Review of Shell's Supplemental Information Round 2 for the Pierre River Mine Project to AENV and ERCB

Mikisew Cree First Nation GIR

Aug 2010

Figure 1: Moose densities (moose per km²) observed in various aerial surveys conducted by regulatory agencies or private industry between the years 1960 and 2008.

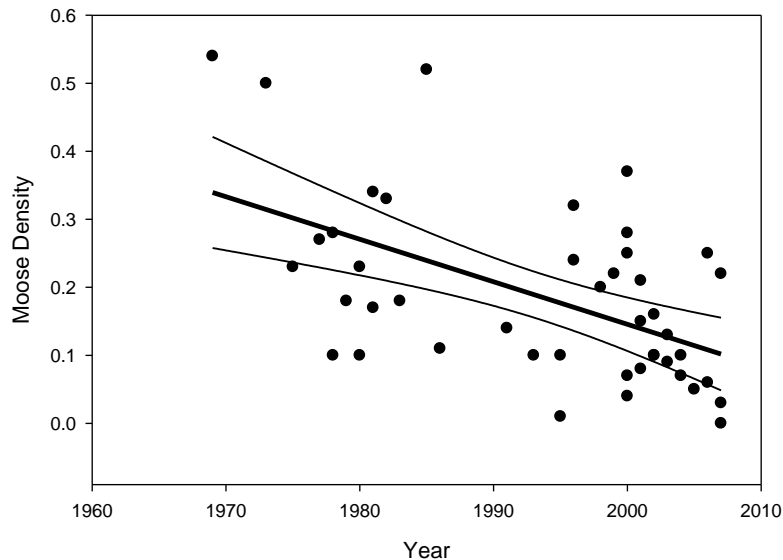
Concern: Shell claims that habitat abundance is not necessarily directly linked to a direct reduction in the abundance of wildlife KIRs and that other factors such as carrying capacity are also important. Shell offers moose as an example of species that will not suffer population decreases due to habitat loss. There is no evidence to suggest that Shell has an understanding of local and regional habitat carrying capacity for moose and that these indicate that habitats can readily accommodate additional moose. It is not clear how Shell presumes that moose population numbers will increase in conjunction with increased levels of human development in northern Alberta through a lowering of predation and harvest rates when oil sands exploitation is improving access for predators and human hunters. One can always make the argument that moose populations will increase if hunting and predation decrease. However, this would be tantamount to stating that moose in a Zoo do just fine given that they have lots of food and are safe from predation.

Indeed, MSES has already demonstrated that oil sands projects result in moose population declines. For example, data collected by Suncor indicates that moose populations are declining (Figure 1). Figure 1 is based on the data provided in of Suncor’s Mine Dump 9 Application (Attachment 1 of the SIRs, Table 5-1, Suncor 2008). It demonstrates that moose density is declining in the region. The declining trend is statistically highly significant (Spearman rank order correlations $r_s = -0.52$, $N = 44$, $p < 0.001$). The declining population trend is not surprising given the increasing conversion of natural land surfaces to industrial development.

Recommendation/Question: We recommend that the Mikisew Cree request that AENV and Shell provide specific regional examples where moose population numbers are increasing because of oil sands development.

Given the amount of leased land in northern Alberta for oil sands exploitation, please provide an estimate regarding the abundance of moose habitat in the region.
